Access Compliance Report

Public Rights-of-Way

(Curb Ramps)

Intersection ID: 10151	Main Street: E_37TH_ST	Cross Street: N_MCDOWELL_ST	Location: S
ADA ID: 87061650D3A5	Ramp Type: Perp	Initial Pass/Fail: Fail	Overall Compliance: No
		Severity Score: 12.5	
Codes/Mitigation Info/Possible Solution		Field Measurements/Component Compliance

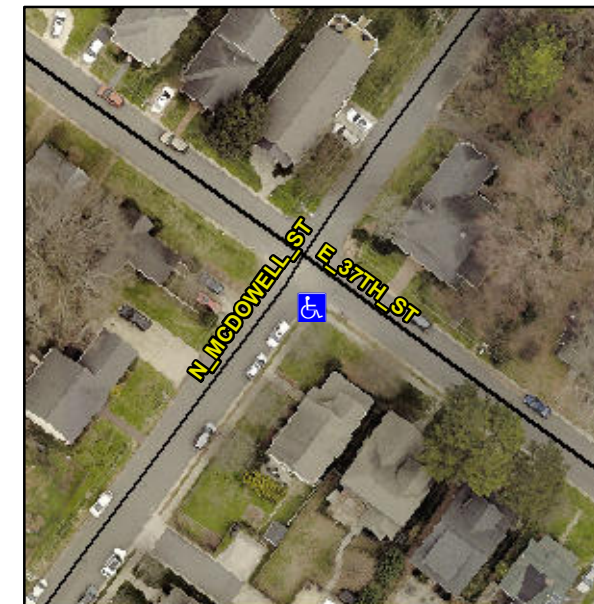
Not Found, R304.5.3

Compliance	Description	Data	Compliance	Description	Data
N/A	Ramp Length (in)	27.0	Yes	Ramp Slope (%)	8.3
Yes	Ramp Width (in)	48.0	No	Ramp XSlope (%)	6.8
N/A	Flare Type LT	N/A	N/A	Flare Type RT	N/A
N/A	Flare Slope LT (%)	N/A	N/A	Flare Slope RT (%)	N/A
N/A	Flare Traversable LT?	N/A	N/A	Flare Traversable RT?	N/A
N/A	Landing Length (in)	N/A	N/A	DWS Provided?	N/A
N/A	Landing Width (in)	N/A	N/A	DWS Contrast?	N/A
N/A	Landing Slope (%)	N/A	N/A	DWS Length (in)	N/A
N/A	Landing X Slope (%)	N/A	N/A	DWS Full Width?	N/A
N/A	Landing Curb? (Y/N)	N/A	N/A	DWS Offset (in)	N/A
N/A	Shared Landing?	N/A			
N/A	Gutter Ponding?	N/A	N/A	Gutter Slope (%)	N/A
N/A	Gutter Lip Ht (in)	N/A	N/A	Gutter X Slope (%)	N/A
N/A	Painted X Walk1?	No	N/A	Painted X Walk2?	N/A
	X Walk 1 Direction	To NW		X Walk 2 Direction	N/A
N/A	X Walk 1 Width (in)	N/A	N/A	X Walk 2 Width (in)	N/A
	X Walk 1 Slope (%)	0.1		X Walk 2 Slope (%)	N/A
	X Walk 1 X Slope (%)	5.8		X Walk 2 X Slope (%)	N/A

Remove & Replace Entire Ramp.
